CITY PLAN COMMISSION**THURSDAY, MAY 22, 2025****FILE NUMBER:** S245-154**SENIOR PLANNER:** Hema Sharma**LOCATION:** Metropolitan Avenue, northeast of Botham Jean Boulevard**DATE FILED:** April 23, 2025**ZONING:** PD 595 (MF-2(A))**PD LINK:** <https://dallascityhall.com/departments/city-attorney/Articles/PDF/Article%20595.pdf>**CITY COUNCIL DISTRICT:** 7**SIZE OF REQUEST:** 0.344-acres**APPLICANT/OWNER:** Bruce Kaminski, Kaminski Custom Builders LLC

REQUEST: An application to replat a 0.344-acre tract of land containing all of Lots 15 and 16 in City Block A/1207 to create one lot on property located on Metropolitan Avenue, northeast of Botham Jean Boulevard.

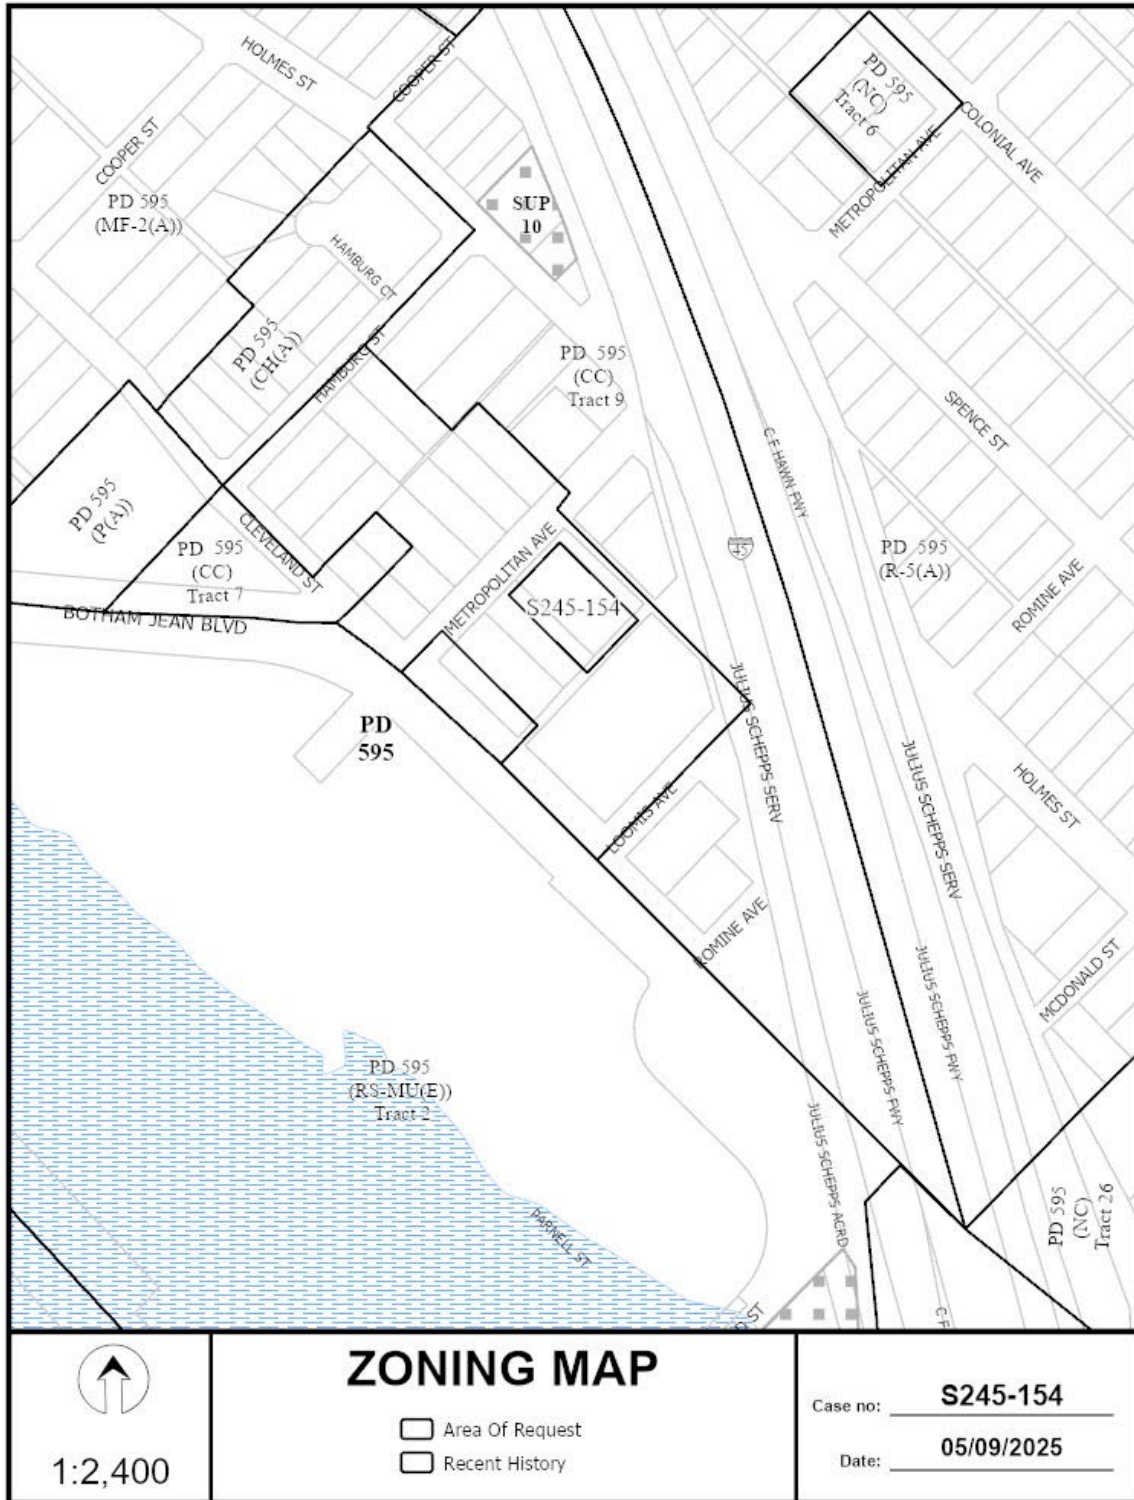
15. On the final plat, dedicate 28 feet of right-of-way (via fee simple or street easement) from the established centerline of Metropolitan Avenue. *Sections 51A-8.602(c), 51A-8.604(c) and 51A-8.611(c).*
16. On the final plat, dedicate a 15-foot by 15-foot Alley Sight Easement at the intersection of Metropolitan Avenue & the alley. *Section 51A-8.602(e)*

17. Prior to final plat, submit a completed final plat checklist and all supporting documents.
18. On the final plat, chose a new or different plat name.

22. Prior to final plat, compliance with City's street lighting standards including illumination standards, material, installation, and activation per Street Design Manual.
23. On the final plat, change "Metropolitan Avenue (FKA Casey Street)" to "Metropolitan Avenue (AKA Metropolitan Street FKA Casey Street)" Section 51A-8.403(a)(1)(A)(xii).
24. On the final plat, change "Julius Schepps Fwy Interstate Hwy 45" to " Julius Schepps Freeway/ Interstate Highway No.45". Section 51A-8.403(a)(1)(A)(xii).
25. On the final plat, identify the property as Lot 15A in City Block A/1207.
